Reference: **ACCESS REPORT**
RSL LIFESTYLE
BIRDWOOD PARK DEVELOPMENT
500 KING ST
NEWCASTLE WEST, NSW 2302

ACCESS REPORT

**BIRDWOOD PARK DEVELOPMENT
500 KING ST
NEWCASTLE WEST 2302**

Project: RSL Lifestyle
 500 King St
 Newcastle West, NSW 2302.

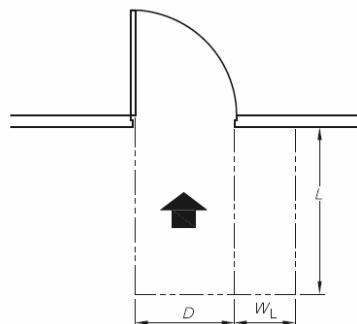
The lobby entry doors are nominated as double leaf assembly. The primary leaf of the doorway will need to have a minimum clear width of 850mm. Latchside clearances will need to comply with Clause 13 of AS1428.1:2009.

The position of the entry doors to individual units will need to be repositioned to provide the required latchside clearances required of Clause 13.3 of AS1428.1:2009.
